# Addendum

Project: West Toronto Community Health Services  
Community Health Centre

Addendum No.: 03

## Architectural Addendum No. A03

3 STAIR @ MECHANICAL ROOM  
1:10

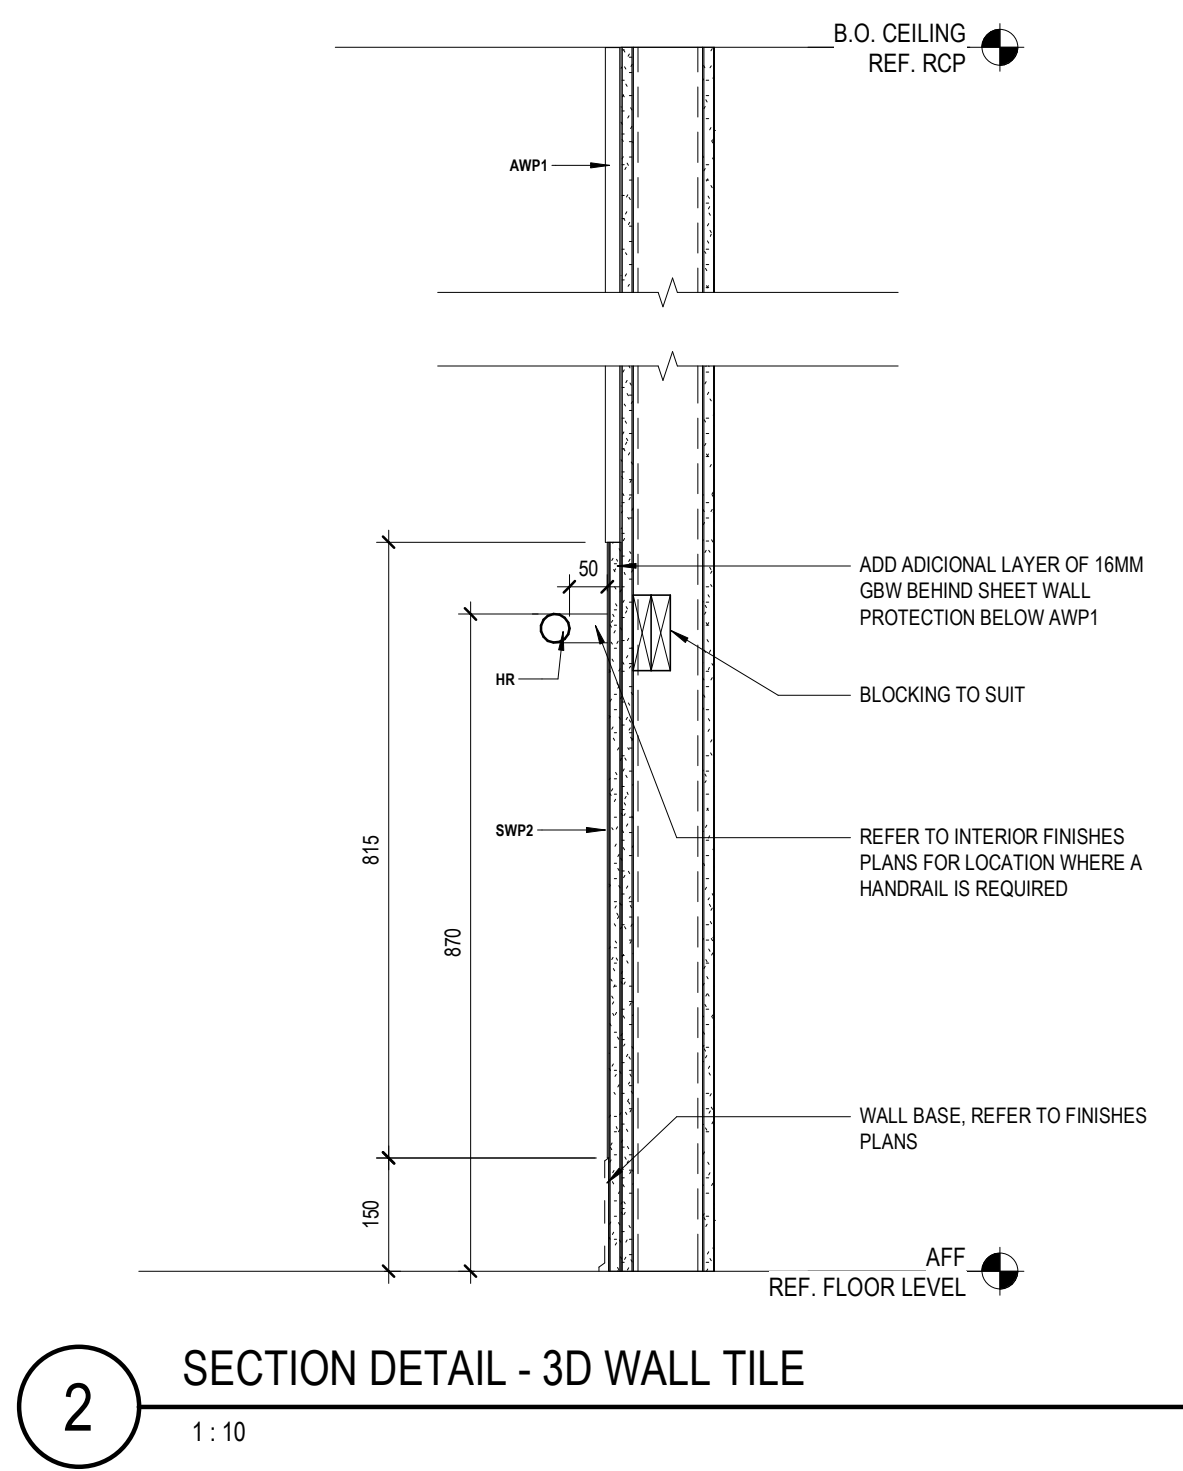
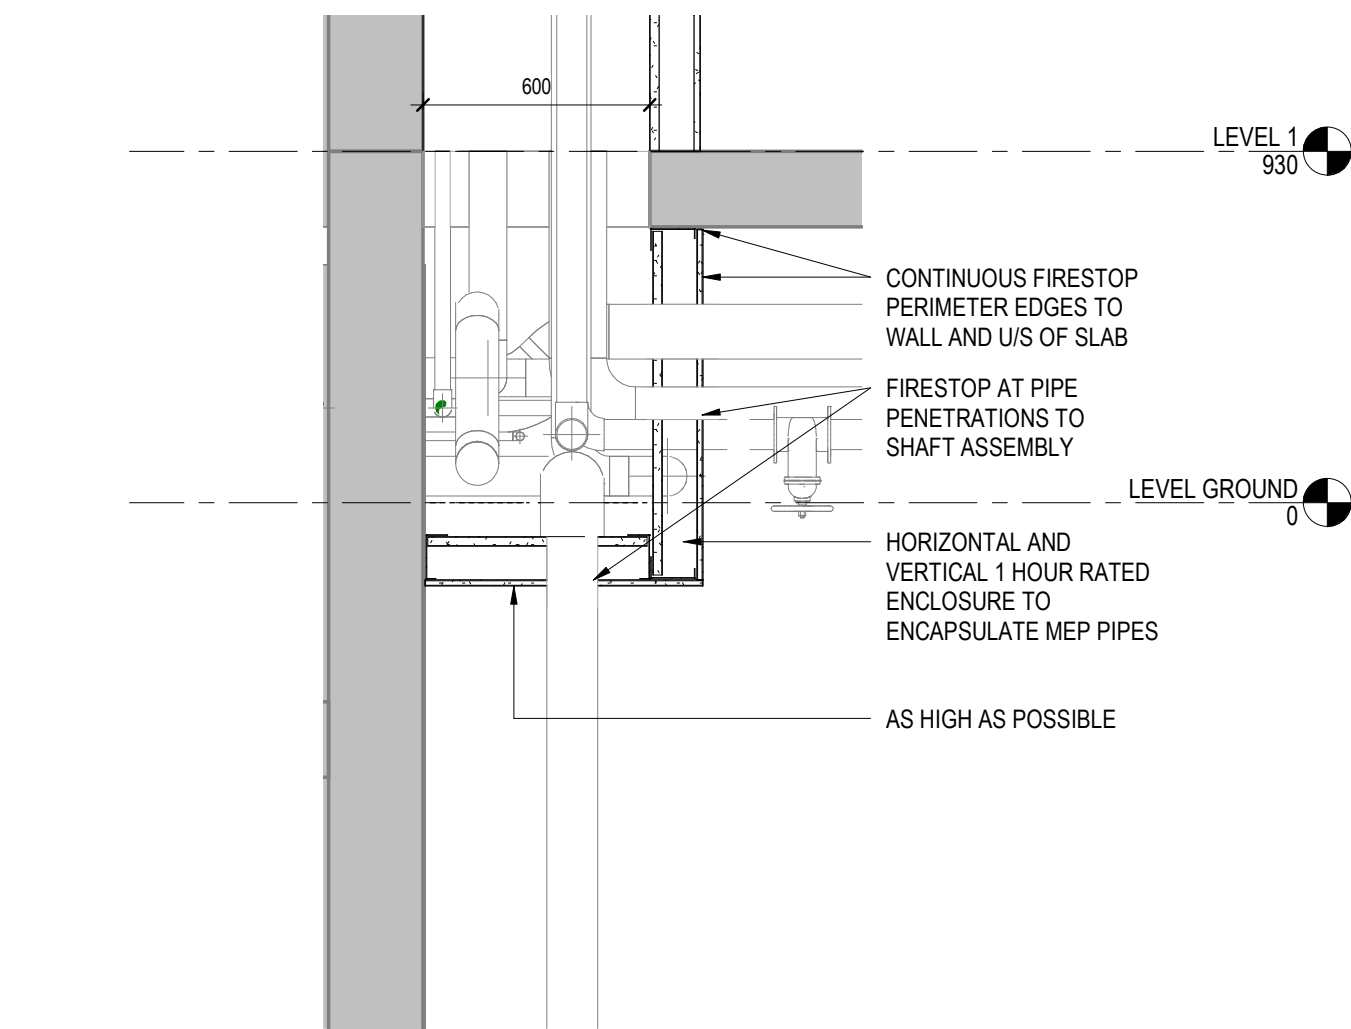
*Refer to detail 3/A-504 Grid line A-B / 7-8, Please provide structural details of SOD, Stair and masonry wall. The only details of this shown are on architectural drawing A504.*

**Refer to Drawing A-504 INTERIOR DETAILS – DETAIL 3 incorporating structural requirements, reissued herewith, dated 2024.10.17.**

A-700

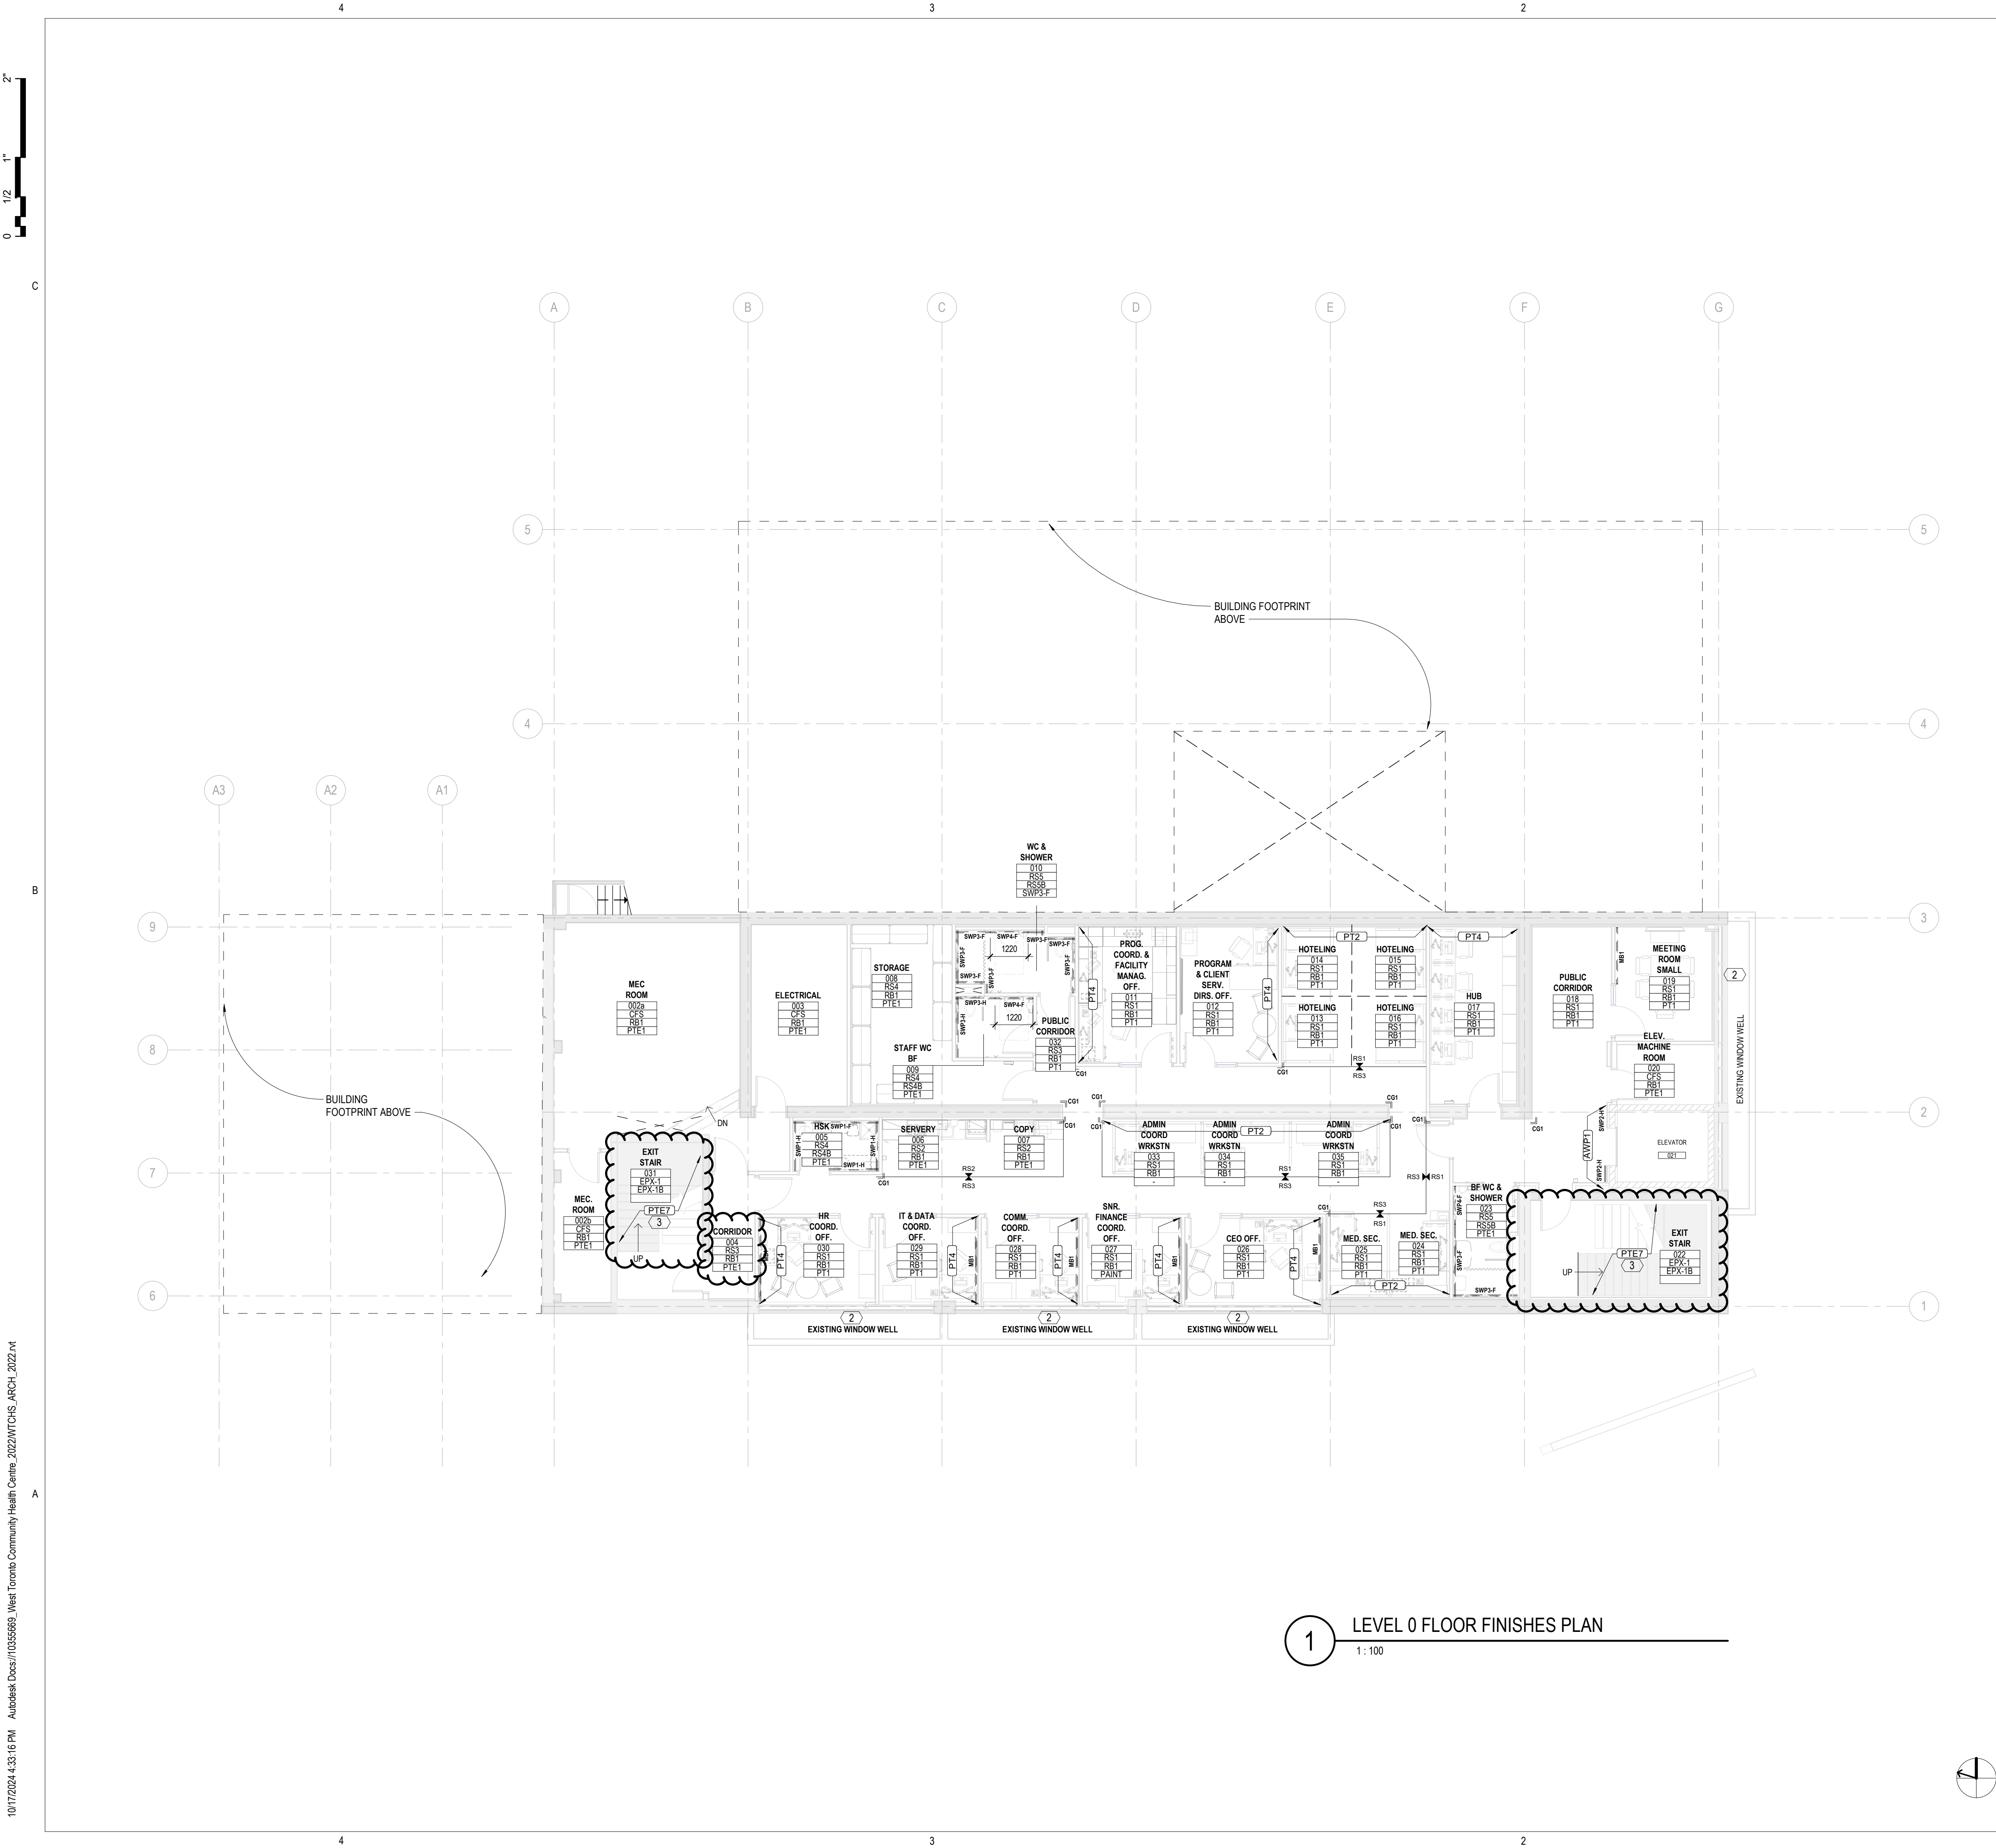
*What is EXP1 on the finishes plans? What is CFS on the finishes plans?*

*Spec section for Epoxy flooring is provided. But it is not clear where does this apply. Please clarify.*

**Refer to Drawings A-001 PROJECT INFORMATION & ABBREVIATIONS and Drawings A-700, A-701 and A-702 INTERIOR FINISHES PLANS reissued herewith, dated 2024.10.17.**

Refer to Drawings A-001 PROJECT INFORMATION & ABBREVIATIONS and A-700, A-701 and A-702 FINISHES PLANS reissued herewith, dated 2024.10.17.
